Addendum to deliverable D5.2 Energy Use Cases, Measurement Methodology & Energy Baseline for the Demonstration Sites

Deliverable Number	:	D5.2 (Y2 addendum)
Title of Deliverable	:	Energy Use Cases, Measurement Methodology & Energy Baseline for the Demonstration Sites
Nature of Deliverable	:	Report
Internal Document Number	:	GENiC_D52_WP5_Y2_addendum
Contractual Delivery Date	:	12
Actual Delivery Date	:	
Work Package	:	WP5
Author(s)	:	Ignacio Torrens (TUE); Juan R. de las Cuevas (ACCIONA)
Total number of pages (including cover)	:	11

Following the submission and review of the re-submitted Deliverable 5.2 in year 2 (originally from Y1) of the GENiC project, an addendum to the original deliverable text was requested to further the discussion on a few topics raised by the reviewers following conditional approval. The comments from the reviewers are presented, followed by the response from the consortium addressing each of the remarks.

Figure 4.27: Tri-generation plant electrical power and efficiency measurements (30/01/2014) (extracted from D5.2)

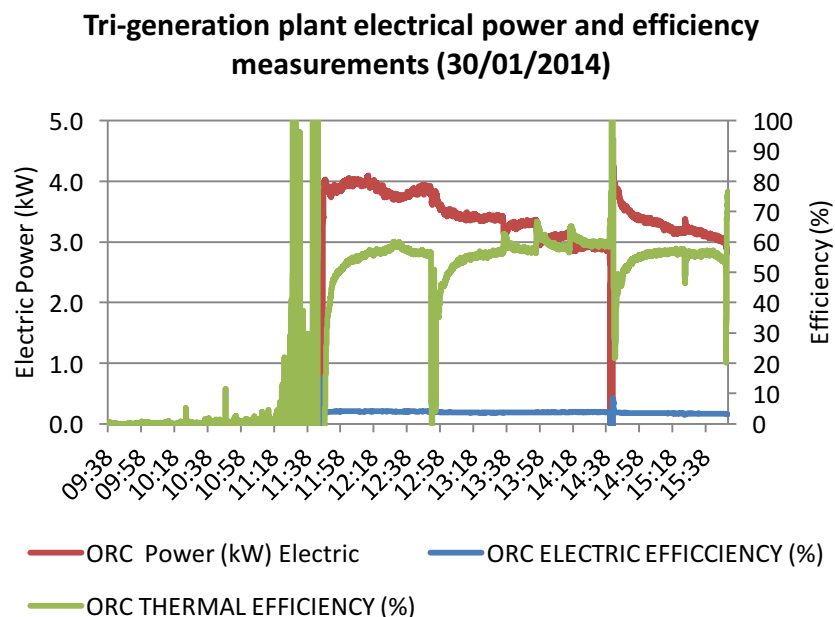
"As shown in Fig. 4.27 the electrical efficiency of the ORC systems is extremely low. Will the project finally suggest such units in DC? If yes, what is the economic evaluation of such systems?"

ORC machine in the experimental plant has an overall efficiency of 95%. Around 10% of the thermal input is converted into electricity and most of the rest is useful heat at low temperature (from 20 to 70°C). The efficiency of commercial ORC goes from 8 to 24% but what needs to be considered is the overall effect of the machine in the facilities, not only the electrical output.

In relation to suggesting ORC for data centres, this will be an outcome of WP6, which is still ongoing.

Figure 4.29: Tri-generation plant absorption chiller heat input, condenser power, cold production and COP measurements (24/03/2014) (extracted from D5.2)

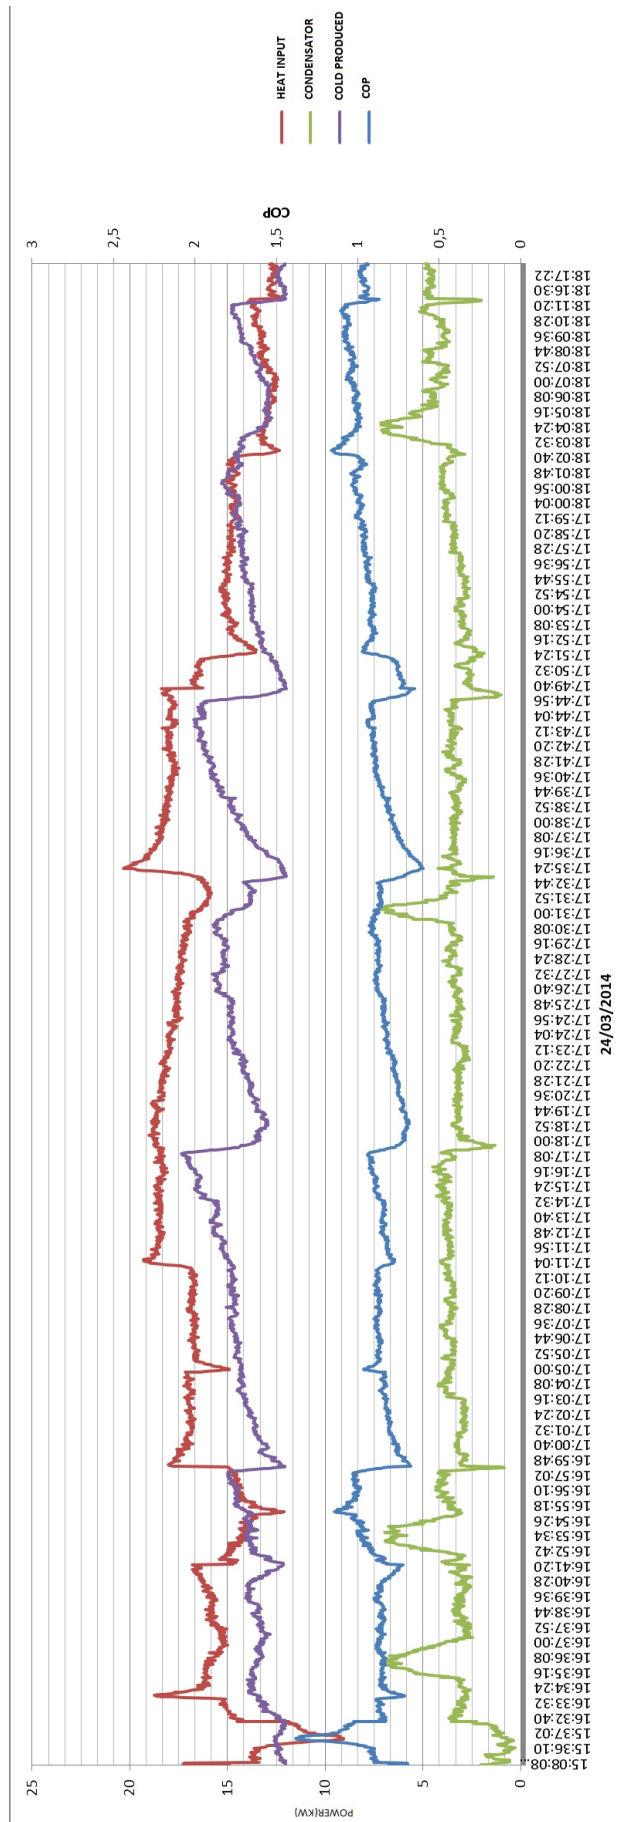
"How useful is a COP<1.2 as shown in Fig. 4.29? An analysis (technical and economic) of systems with low efficiencies must be provided to prove that they are viable for DC (taking into account their physical dimensions too)"

Again, a value of 1,2 is the COP of the absorption chiller, which is just one component of a larger system. 1.2 is a normal COP for that technology, and the technical and economic analysis will have to be focused on the whole system, not only in one of the components, and this analysis is another outcome of WP6 that is currently ongoing. Results will be presented in Deliverable 6.2.: "Strategies validation at tests beds"
